Project Name: USC Aiken Outdoor Storage Building

Project Number: FP00000362

### **Addendum Number Three**

May 12, 2020

Attachment: Updated Civil Drawing C102.01  
End of Addendum Three

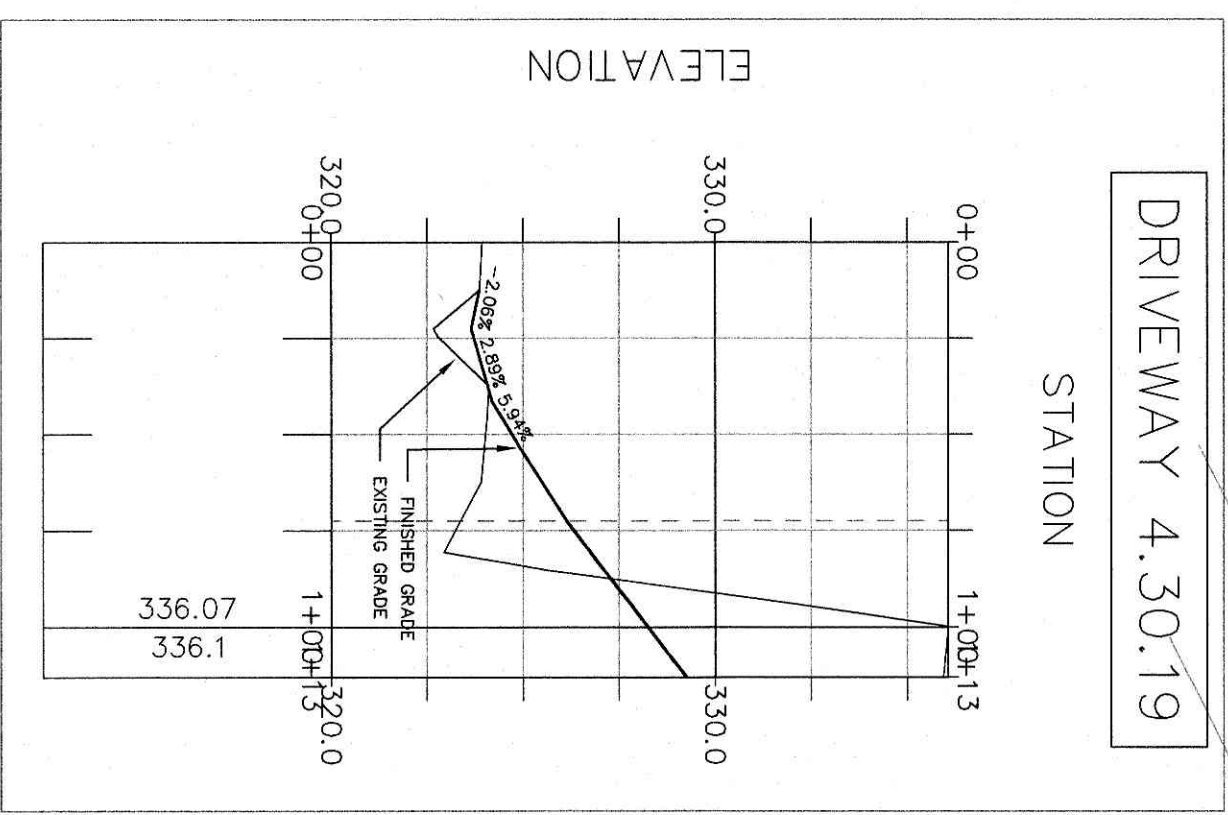
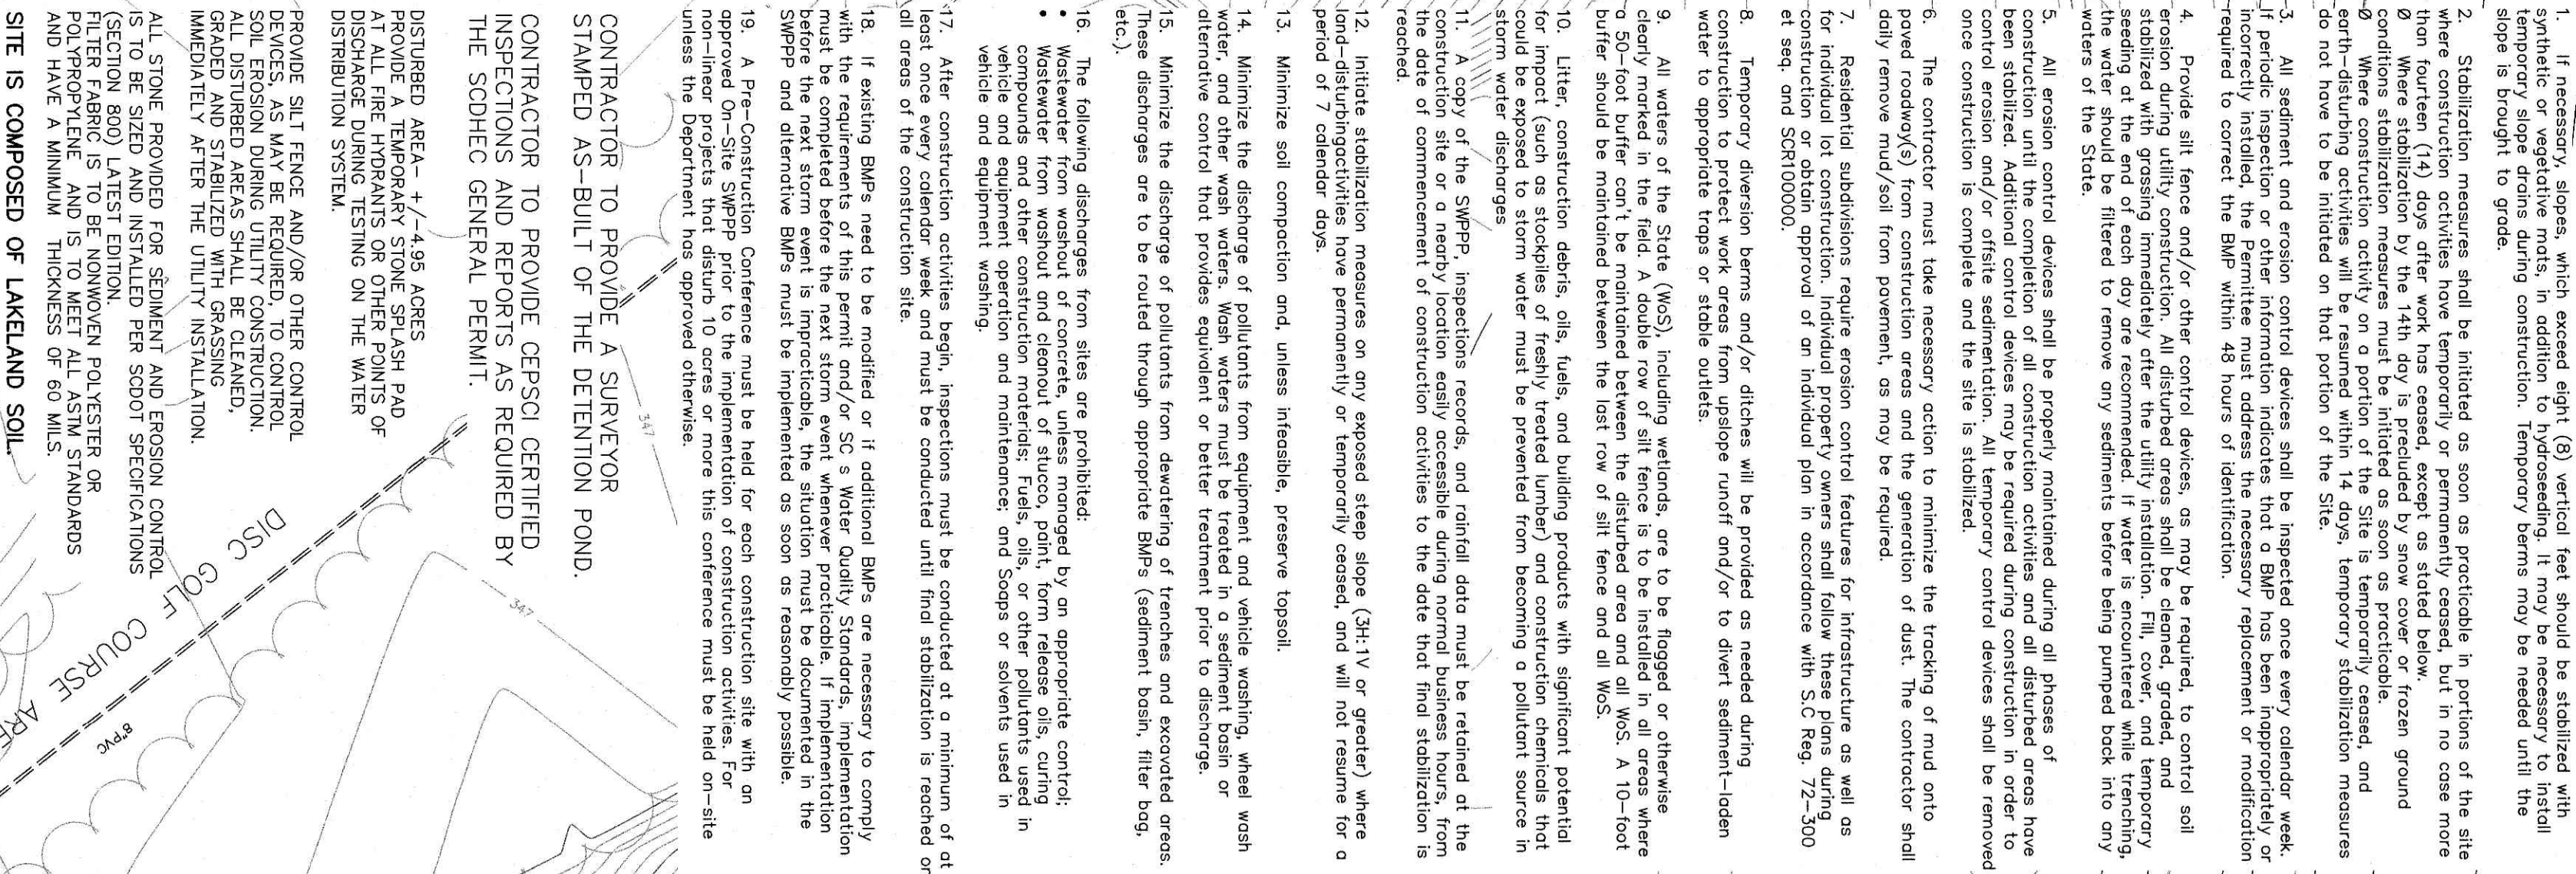
4) Ref. Dwg. C102.1 - Will all of the site work be completed under the "Maintenance Building" contract and therefore we can base our bid on the **finish** elevations shown? [Additional grading will be required to get the building pad to sub-grade. Please refer to the updated civil drawing C102.1](#)

9. Will there be grading work required for the Outdoor Storage Building? Yes. Additional grading will be required to get the building pad to sub-grade. Please refer to the updated civil drawing C102.1

10. It appears that the finished floor elevation of the building pad should be 335.5 ft.? It designates 337.5 ft. on drawing C101. Please confirm. Finish floor elevation has been modified. Reference updated civil drawing C102.1

11. Will the spot elevations along the north and west sides of the Service Lot asphalt pavement be adjusted to an elevation of 335.5 ft. to match the elevation of the Outdoor Storage Building? Yes. Reference updated civil drawing C102.1

12. Will the Grate inlet elevations in the Service Lot need to be adjusted for account for asphalt pavement spot elevation adjustments? Reference updated civil drawing C102.1

13. The 20'x20' Wash Pad specified on page 86 of the project specifications is shown on the architectural drawing A101. Will this abut the Outdoor Storage Building at the same finished floor elevation? The location is not shown on the civil drawings. Yes. Wash pad is to be included and abut the storage building. Reference updated civil drawing C102.1
